Service Bulletin

PRELIMINARY INFORMATION

Subject: Itch Squeak Type Noise From HUD Area

Models: 2015 Cadillac Escalade Models
2015 GMC Yukon Models
With Head-Up Display (RPO UV6)

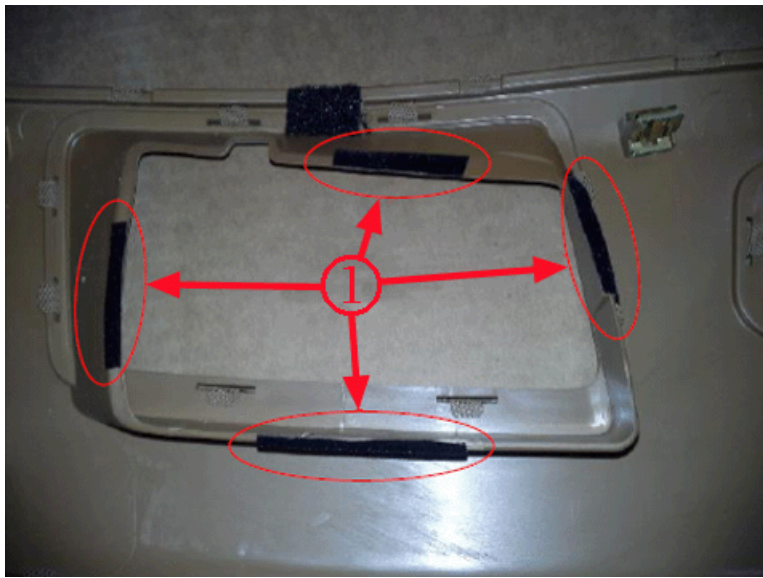
The noise could be caused by the Heads-Up Display (HUD) lense rubbing on the HUD shroud. The HUD shroud is part of the Upper Instrument Panel Extension, as shown below.

The HUD shroud may have four areas with felt tape (1), as shown below, which is inadequate to eliminate this noise.

To correct this concern, add 1 mm thick felt tape, obtained locally, to the full perimeter of the HUD shroud (2), as shown below.
